# TECHNICAL BULLETIN

## TRI-FUNCTIONAL® III BUSHINGS

SUBJECT: Installation Instructions Supplement

LIT NO: L774

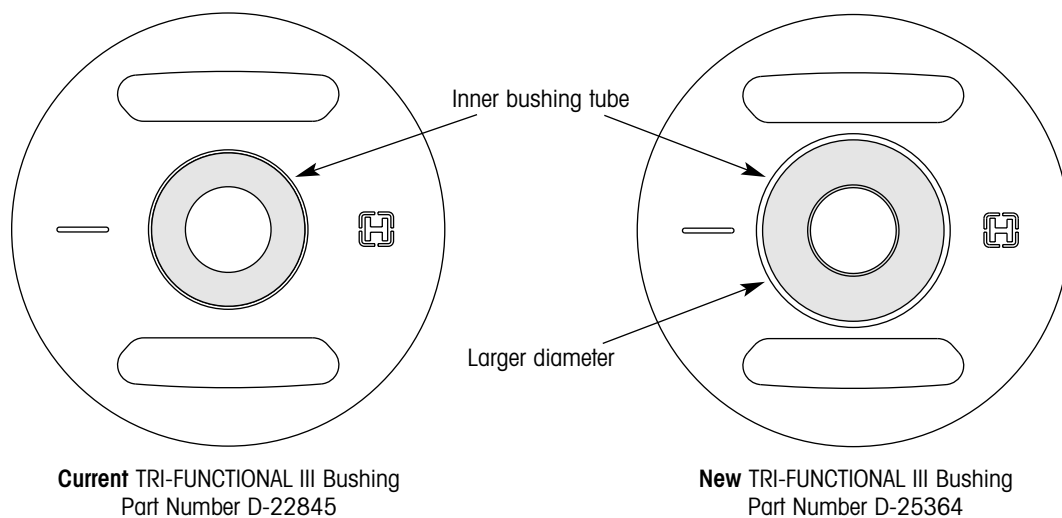
This pivot bushing kit contains the new TRI-FUNCTIONAL® III Bushing. It can be distinguished from the current bushing by the larger-diameter inner bushing tube.

We also increased the stiffness of the new TRI-FUNCTIONAL III Bushing, making it more durable than the current bushing. Because of the increased stiffness and durability, the new and current bushings will wear unevenly if used on the same axle. Therefore, **the new TRI-FUNCTIONAL III Bushing and the current bushing must not be mixed on the same axle. The new TRI-FUNCTIONAL III Bushings in this kit must be installed in both suspension pivot connections.**
